**TRANSMITTAL OF AMENDMENT TO THE OPERABLE UNIT 1 REMEDIAL  
DESIGN PRE-FINAL DESIGN PACKAGES I AND II, SITE IMPROVEMENT  
PLAN, MARCH 1996**

DOE-1021-96

**AMENDMENT TO THE OU1 REMEDIAL DESIGN  
PRE-FINAL DESIGN PACKAGES, I AND II  
SITE IMPROVEMENT PLAN  
MARCH 1996**

FIGURE 2-1. DEPICTION OF AREA 1 PHASE 1 ACTIVITIES

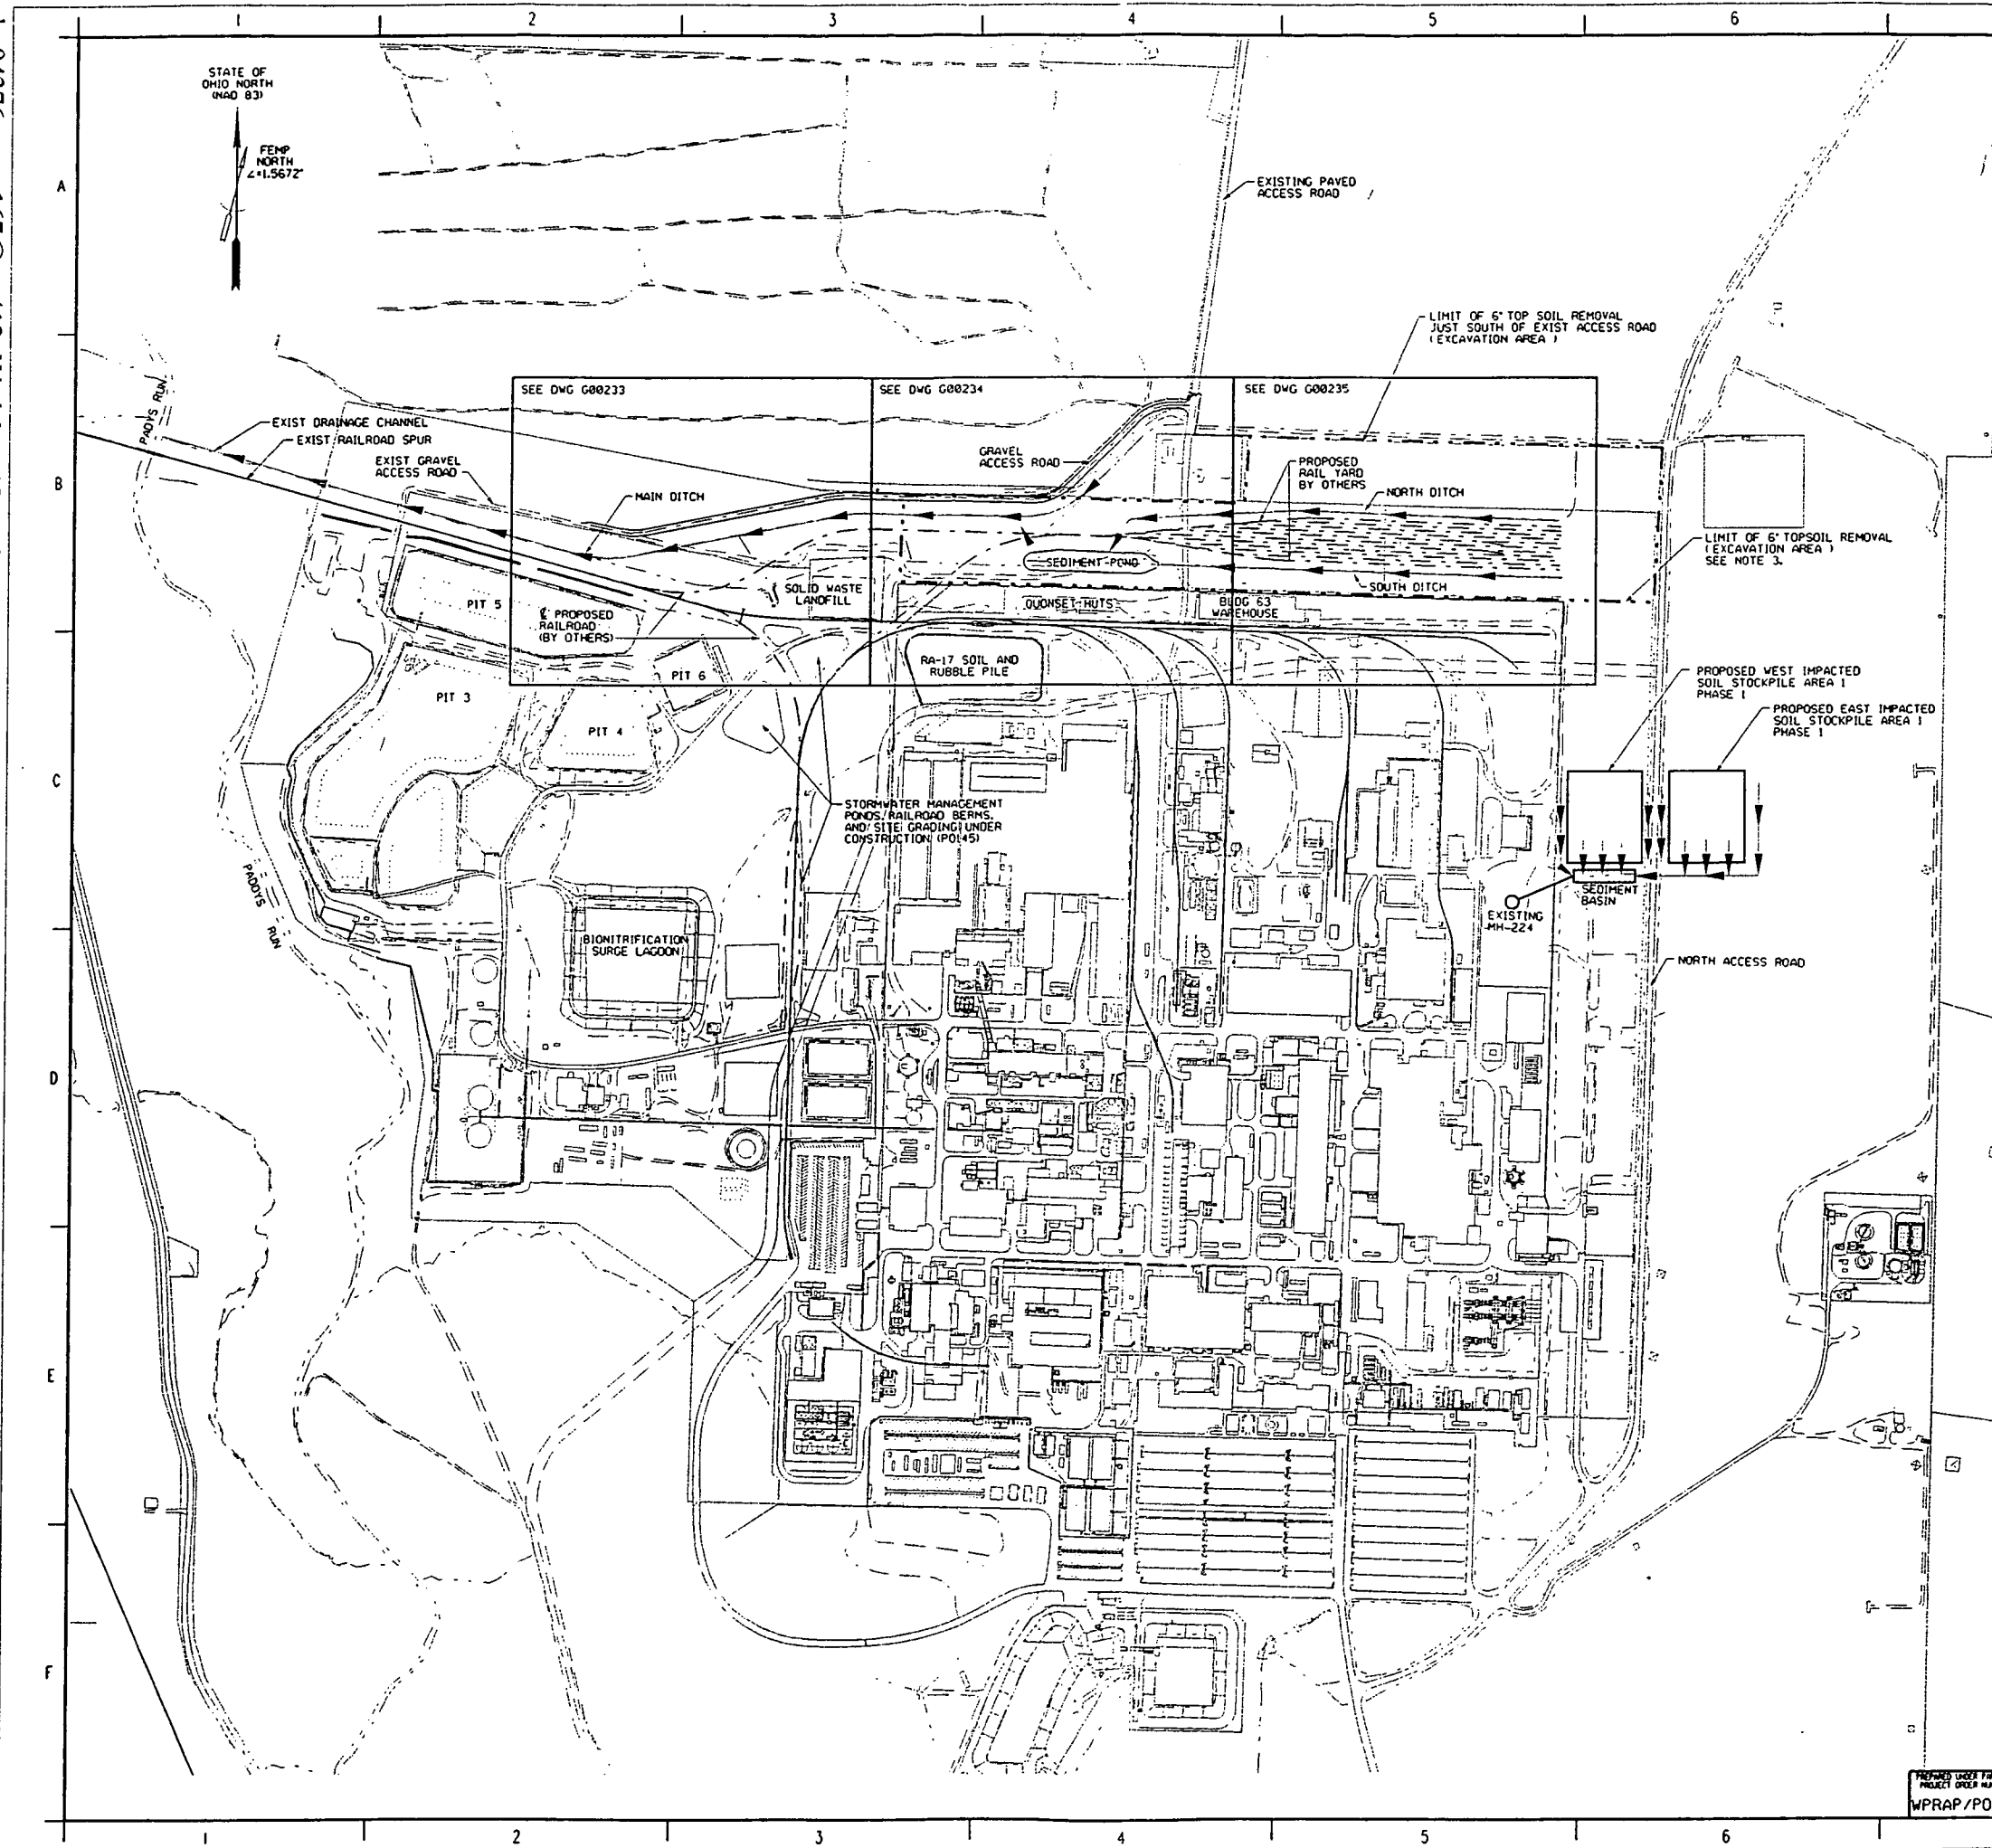
- 1) Stripping of the topsoil (i.e., the surficial 6 inches) from the Areas D north and south and B southwest, see attached Figure 2-1.
- 2) Placement of this topsoil in the stockpile, see attached Area 1 Phase 1 (West) Remedial Action Project plan and detail sheets.
- 3) Management of runoff from the west and east impacted soil stockpiles.

DRAWING TITLE  
**CIVIL  
GRADING AND DRAINAGE  
MASTER SITE PLAN**

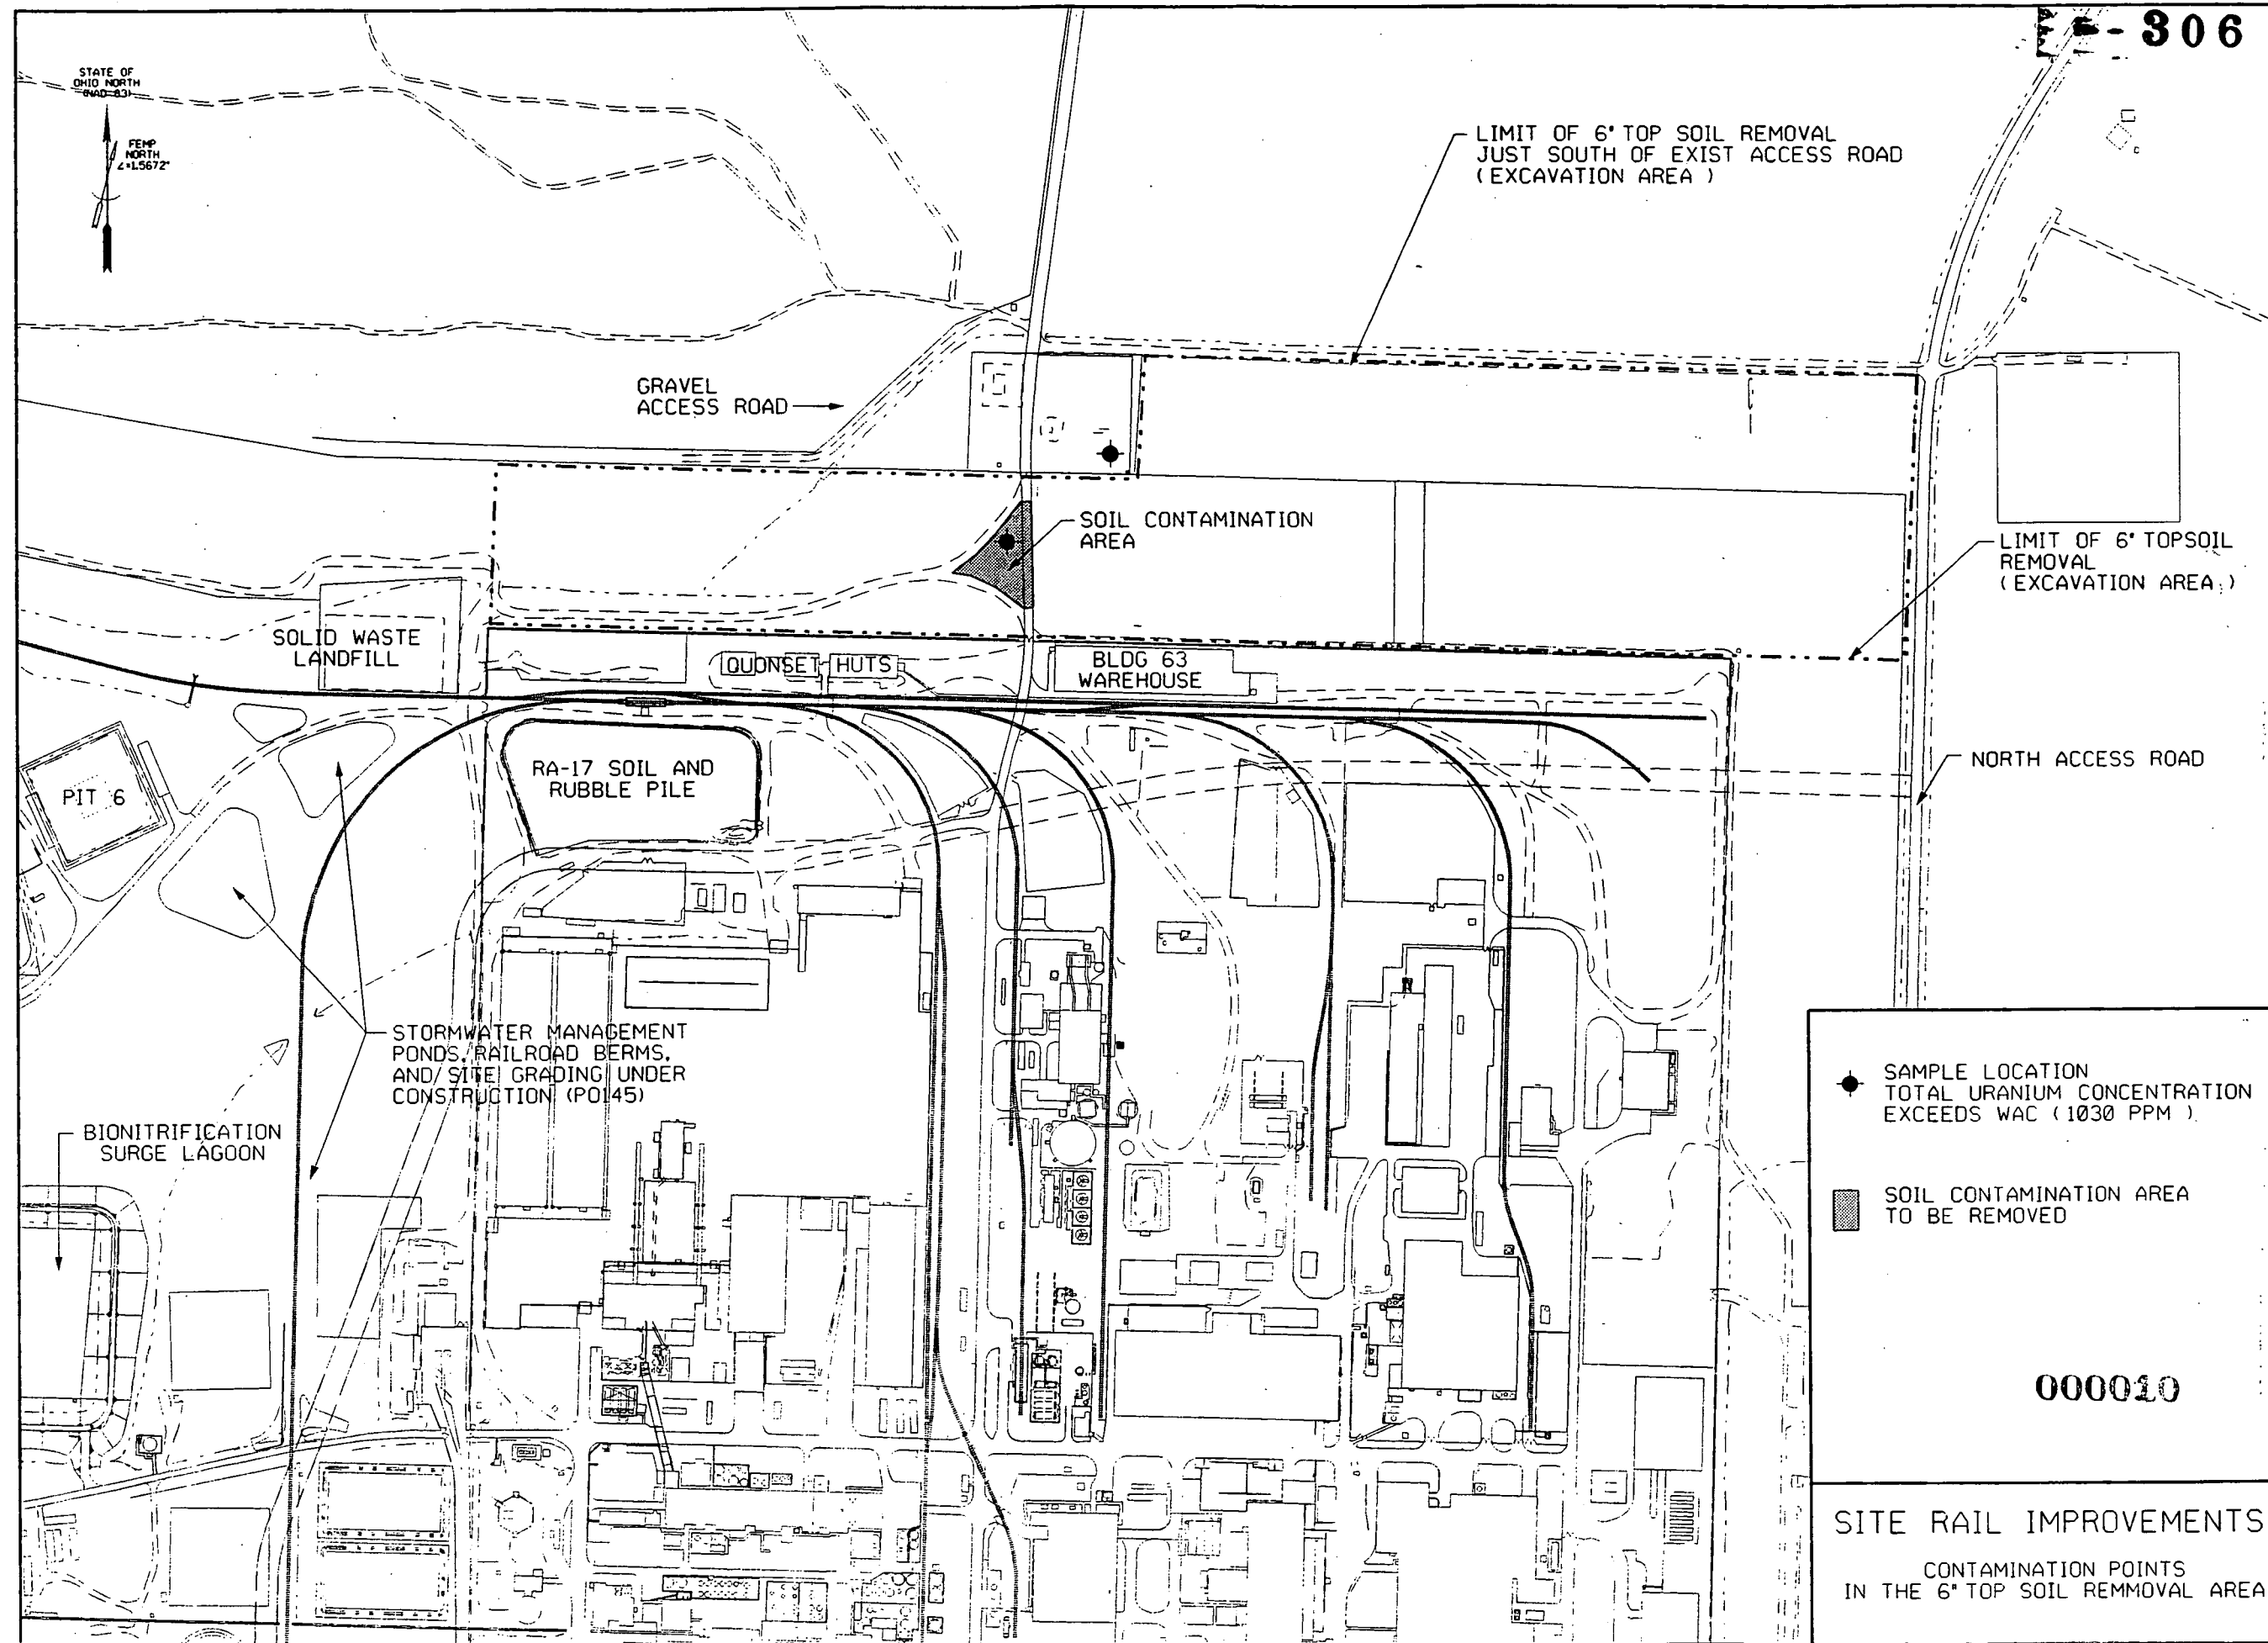
As discussed on Page 5 of the enclosed narrative, two locations were included in the Operable Unit 5 (OU5) Remedial Investigation which were above the Waste Acceptance Criteria (WAC) of 1030 ppm (total uranium). Only one of these sample locations falls within the north railyard area. This area will be removed and placed with other soil and debris from the OU1 preparation activities that will be addressed in the OU1 remediation facility.

Sampling and analysis during the OU5 Remedial Investigation provided total uranium concentrations from 0-6", 6-12", and 12-18" in locations which included the north railyard area. The attached drawing, Site Rail Improvements - Contaminated Points in 6" Topsoil Removal Area, shows the north railyard and surrounding area with the only two data points in that area that exceeded the OSDF WAC - one data point outside the scope of north railyard activities and one data point in the north railyard area of excavation. As indicated in the attached drawing, this data point is located in an area designated for segregation as a result of site radiological control requirements. Prior to stripping the top 6 inches, this area will be removed. The soil and any contaminated asphalt from the adjacent road will be managed (as indicated in the Site Improvement Plan and the Site Preparation Activities letter) within the OU1 boundary with other soil and debris generated from OU1 site preparation activities that are destined for eventual treatment in the OU1 remediation facility. Once this area is removed, stripping of the top 6 inches will proceed. SRP personnel will follow the scraping of these areas with radiological testing. Excavation and grading of the rail areas will proceed next with excess soil (28,000 cyd total) being transported to the OU1 Plant facility. Construction of the rails, ties, and loadout facility with track scale will finish preparatory and upgrade activities.

- SAMPLE LOCATION  
TOTAL URANIUM CONCENTRATION  
EXCEEDS WAC (1030 PPM)
- SOIL CONTAMINATION AREA  
TO BE REMOVED
